BMP NUMBER: JR048

Project Name: Greensprings West, Phase I
Structure/BMP Name: Lake F Wet Pond (JR048)
Project Location: Centerville Rd at Manorgate Dr.
BMP Location: Manorgate Dr. at Longview Landing
County Plan No.: 46-1S - 18 - 1-1 99

S-18-99; JR048 AS-BUILT DRAWING-1/10/01 SJT REVIEW SET

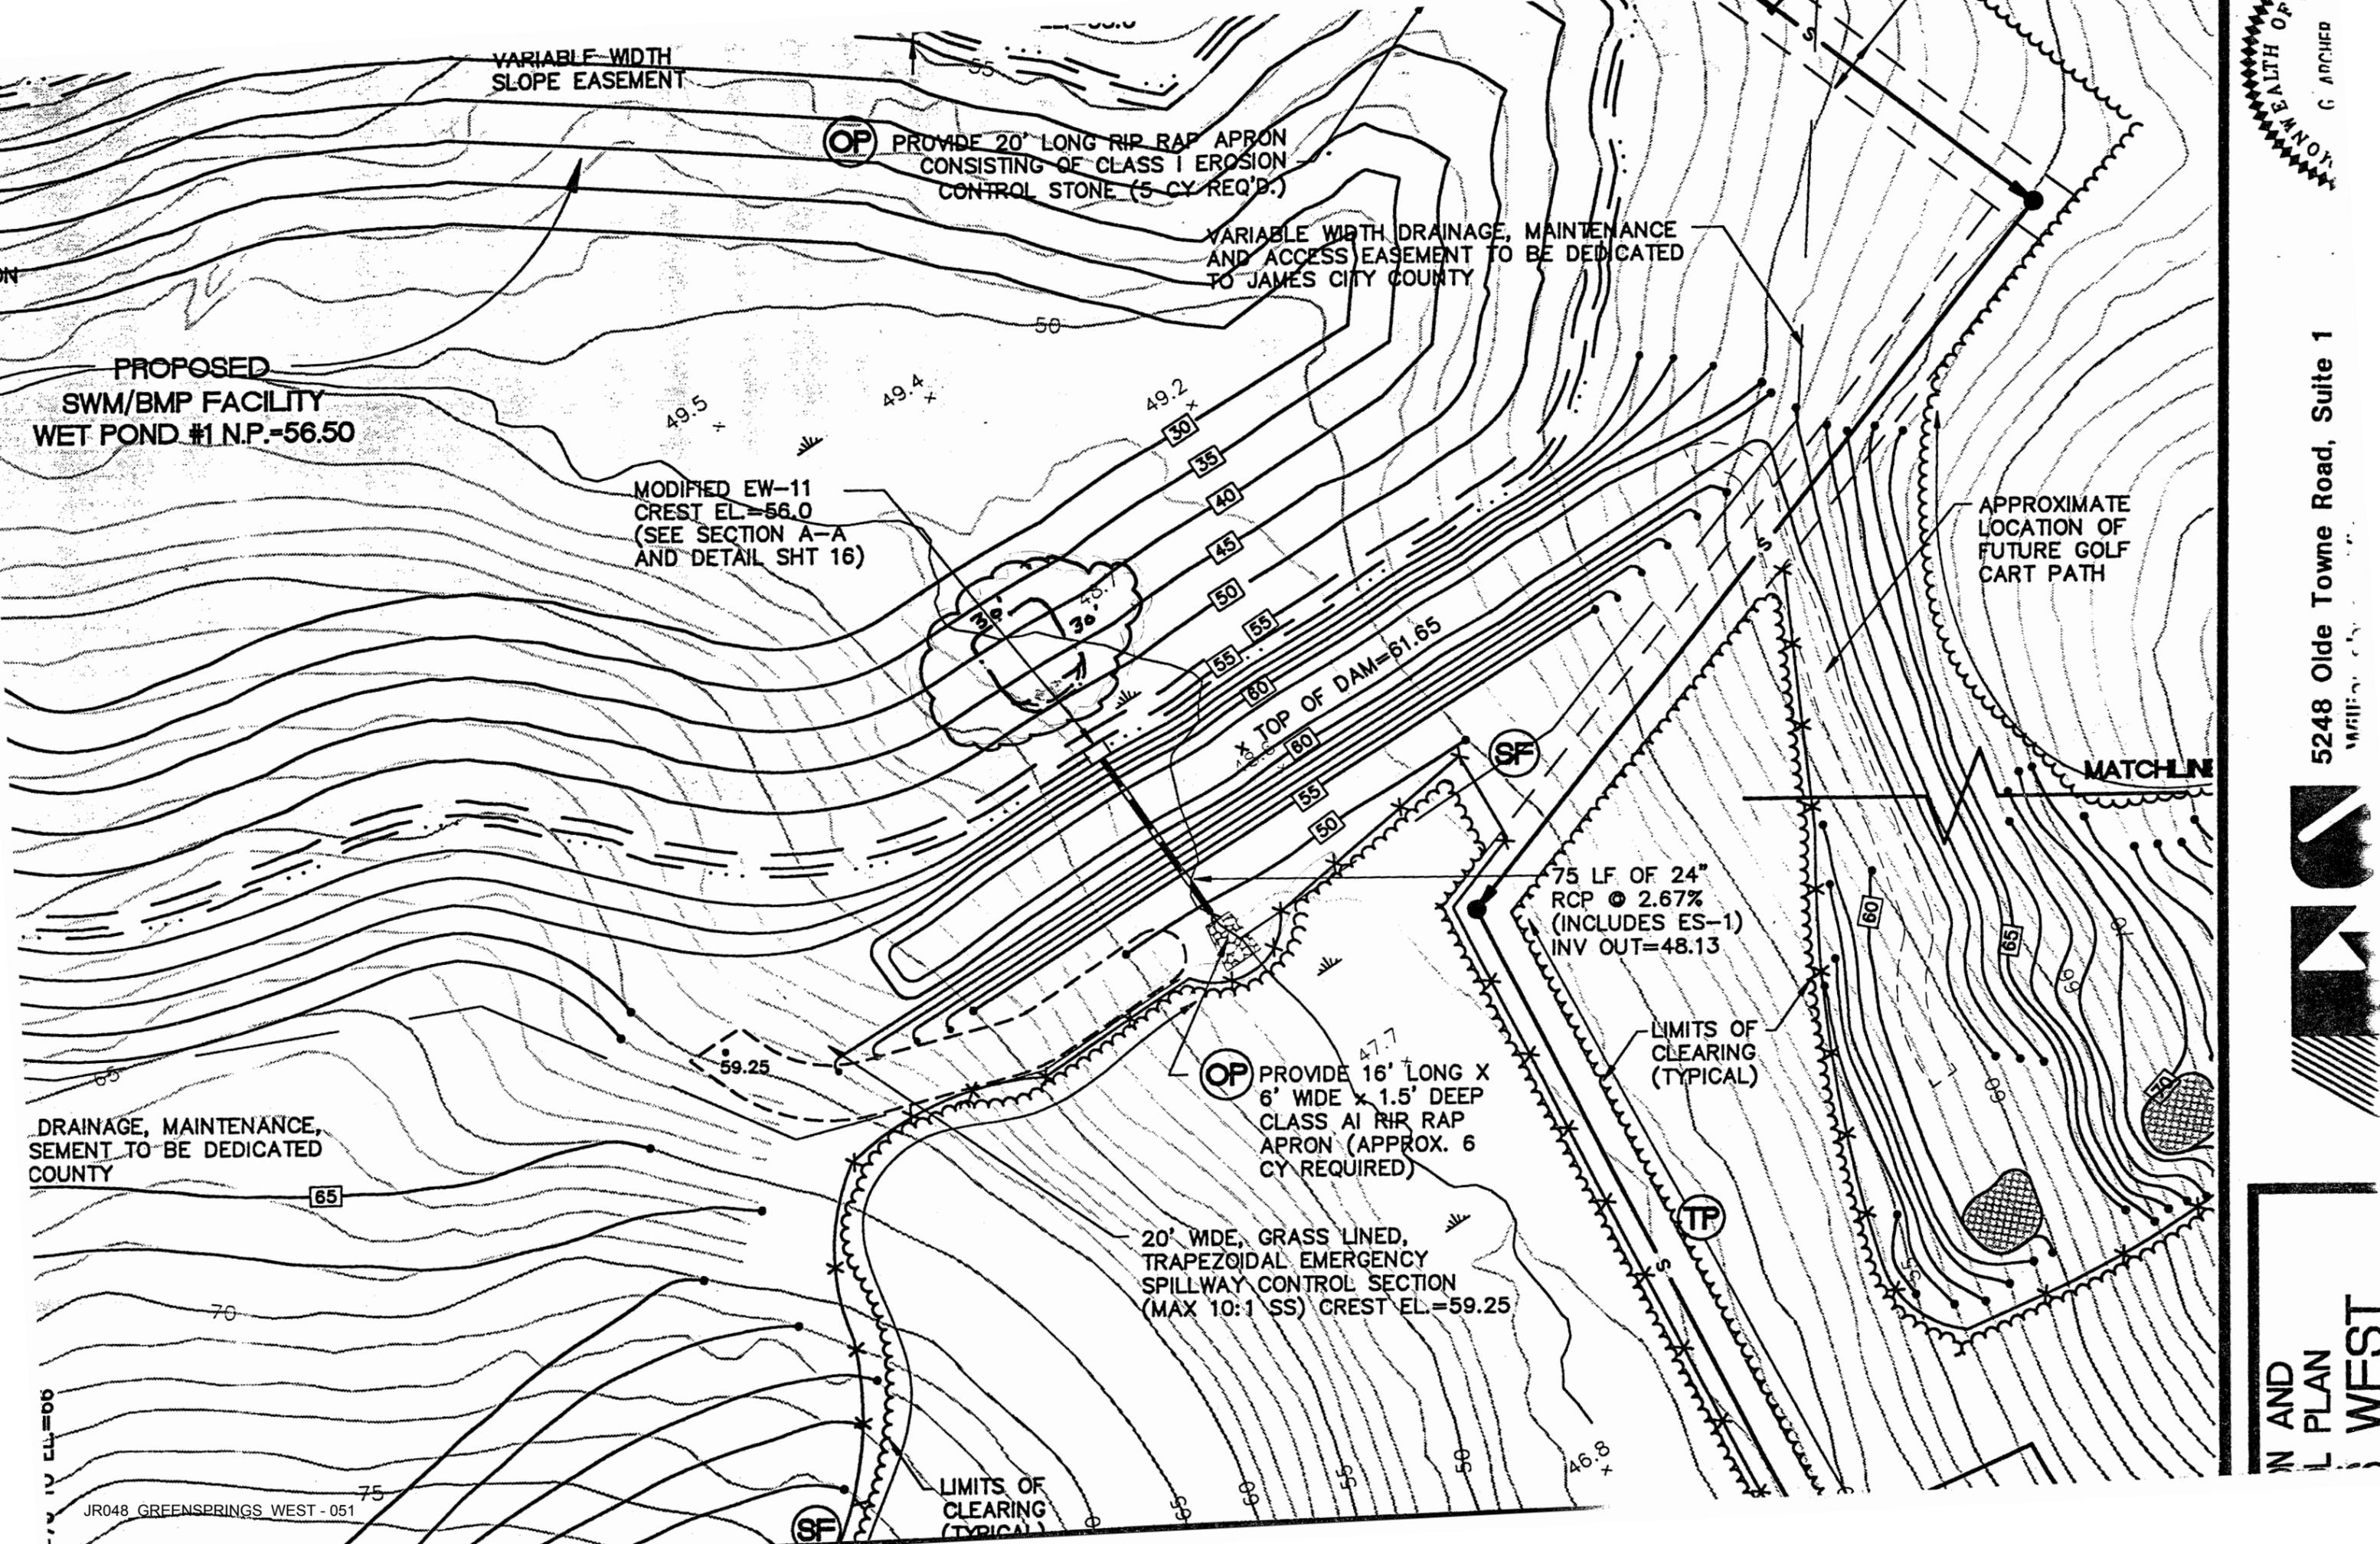
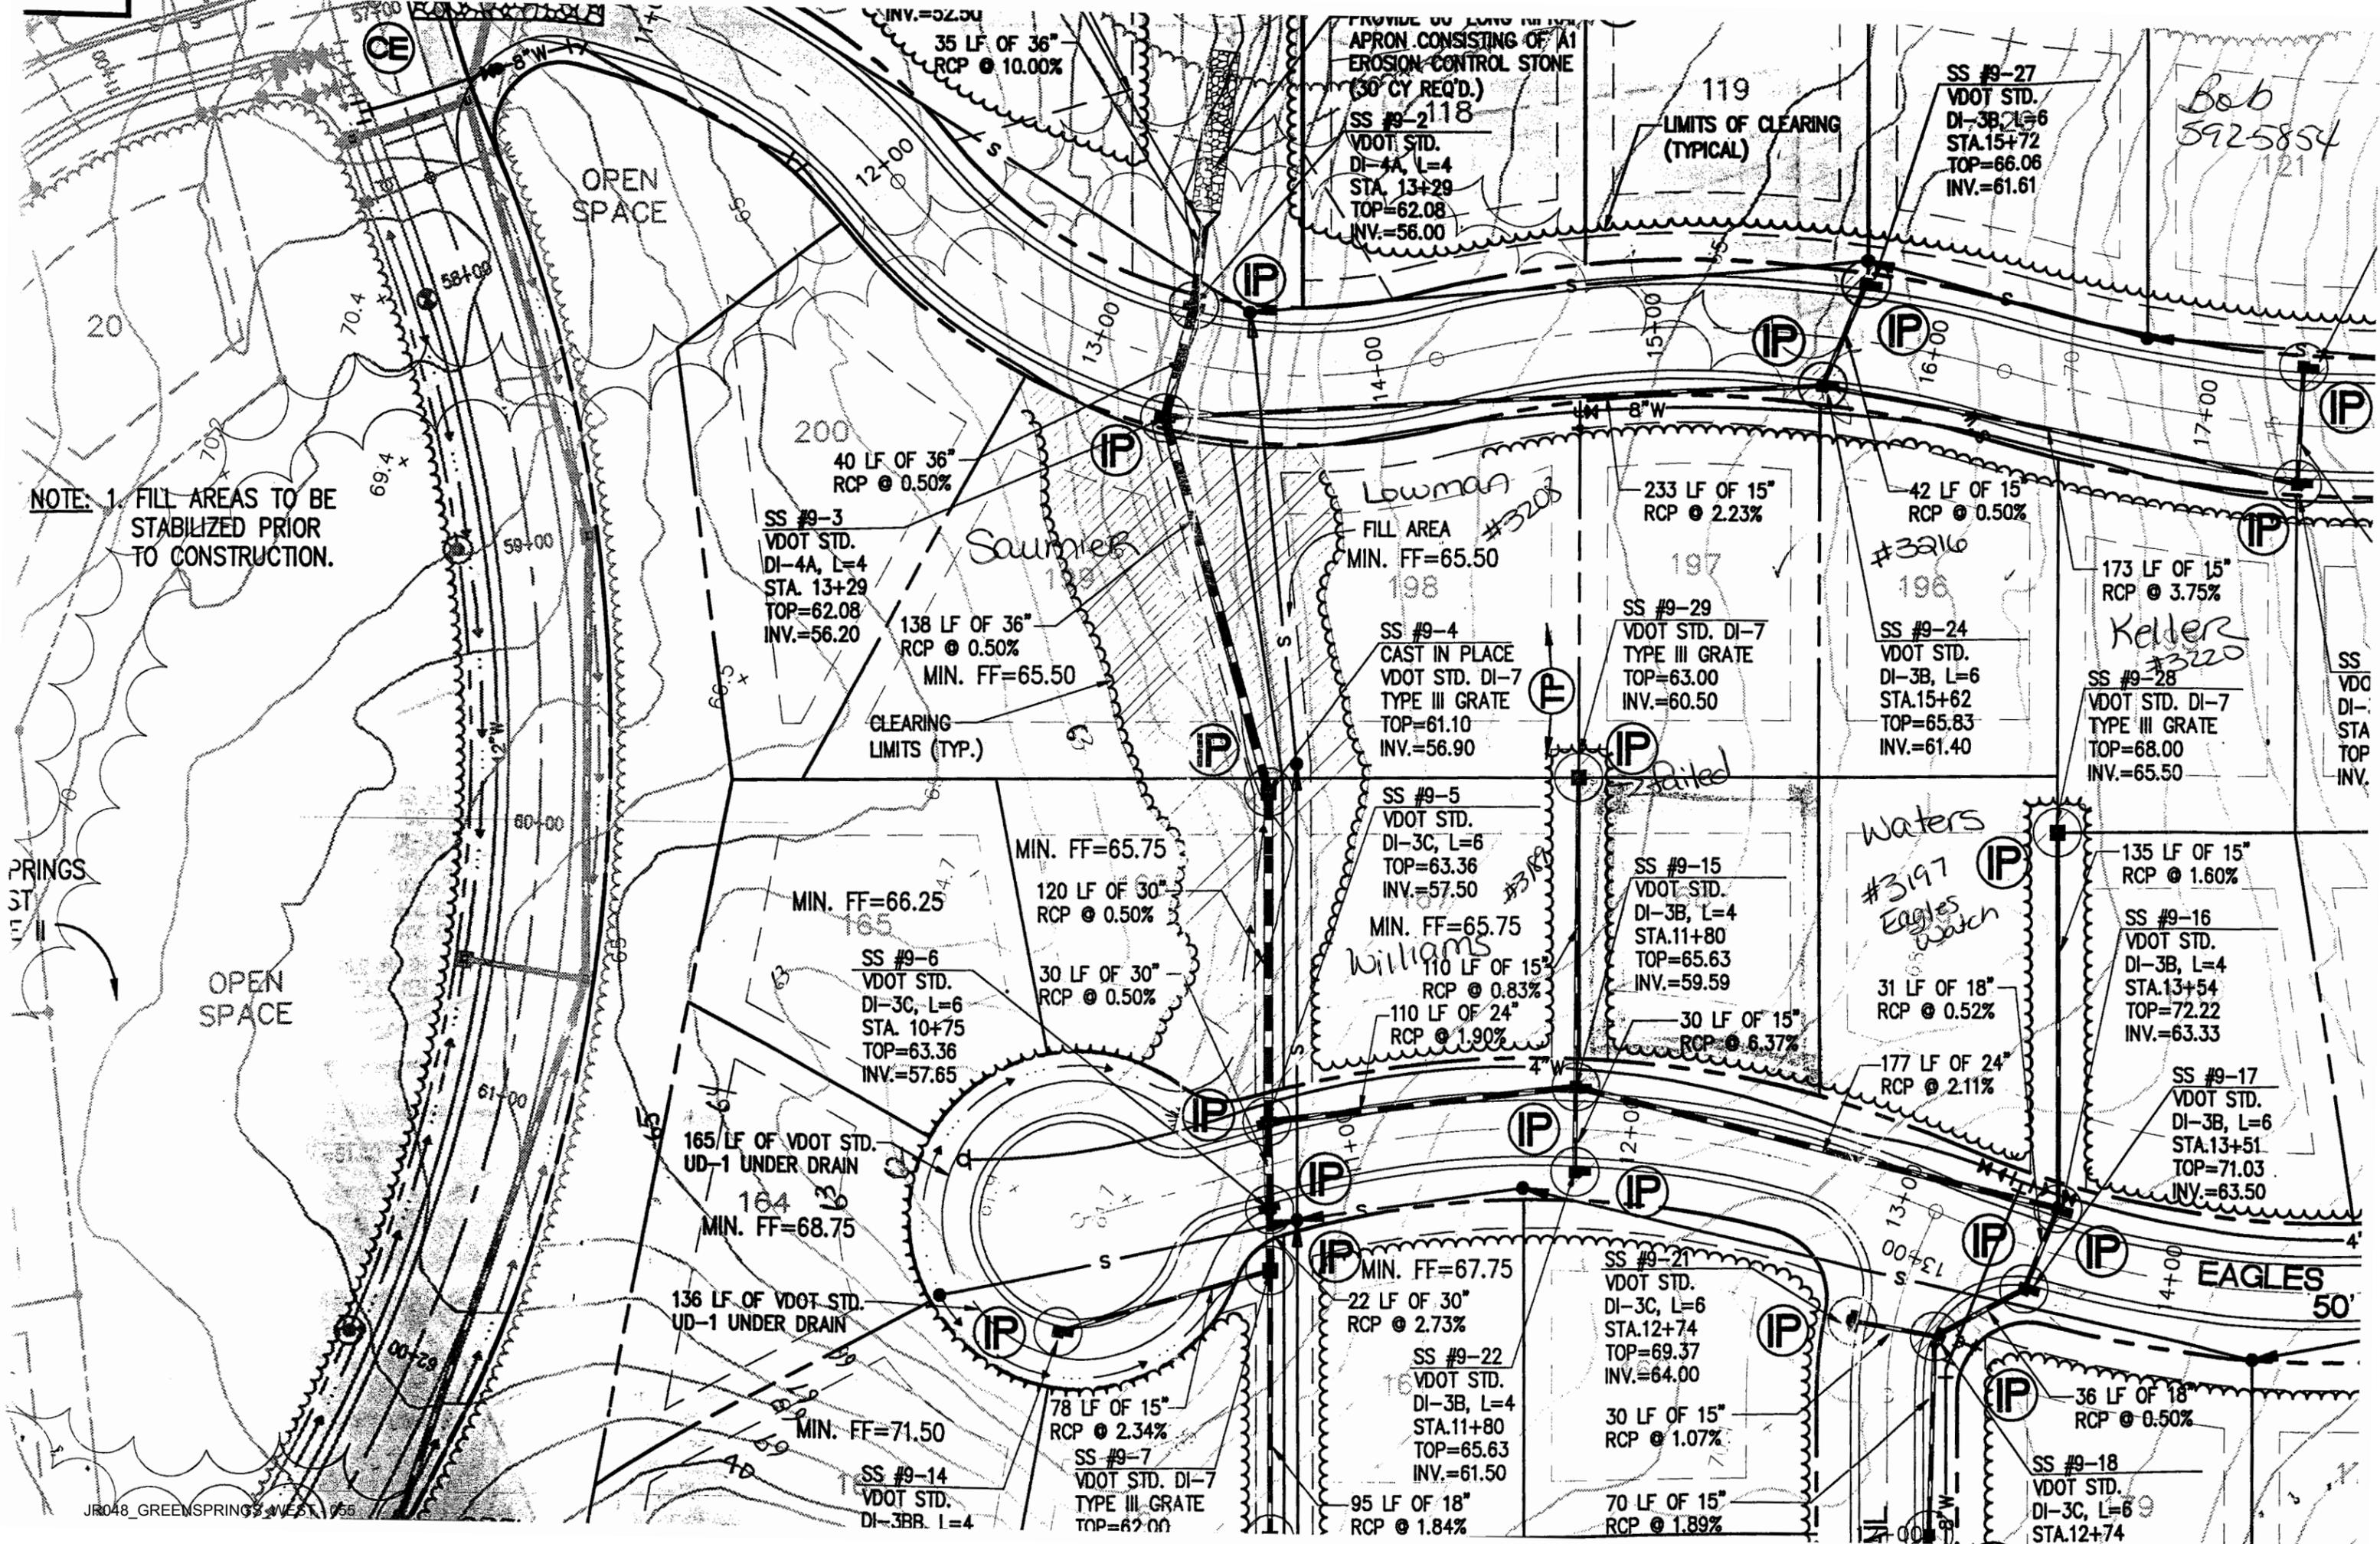
1. Label the facility as "Lake F" on the record drawing, consistent with master plan designations.
Response: The facility has been labeled "Lake F" as requested. Please refer to Plan Sheet 8.

2. Label all roadways and lot numbers and subdivision sections on the record drawing.
Response: The requested information has been added to Plan Sheet 8 as requested.

3. Label the pump station below the Lake F dam as JCSA Lift Station # 9-6.
Response: The requested information has been added to Plan Sheet 8 as requested.

4. Additional as-built spot elevations are needed between the landscaping berms along top of dam. Although as-built top of dam elevation is shown at El. 62 on the cross-section on record drawing Sheet 2, contour and plan information on Sheet I shows that top of dam elevations may be lower than El. 62.

4. The existing wetlands permit does not allow for the filling of the large wetland area northwest of the pond. The grading plan on sheet 8 needs to be revised to eliminate the filling of this area and the grading between this area and the pond. The grading will cutoff the drainage from the wetland area into the pond and create a drainage problem.

Response: Additional spot elevations were added to the top of dam as requested. Please refer to Plan Sheet 8.
5. The riser for the BMP is situated in the southern end of the wet pond is a 60-inch diameter riser. Riser crest controls normal pool. The as-built elevation of the crest of the riser is 0.96 feet higher than that approved in the design plan which results in a normal (permanent) pool elevation higher than the approved plan. This is not in conformance with the approved plan.
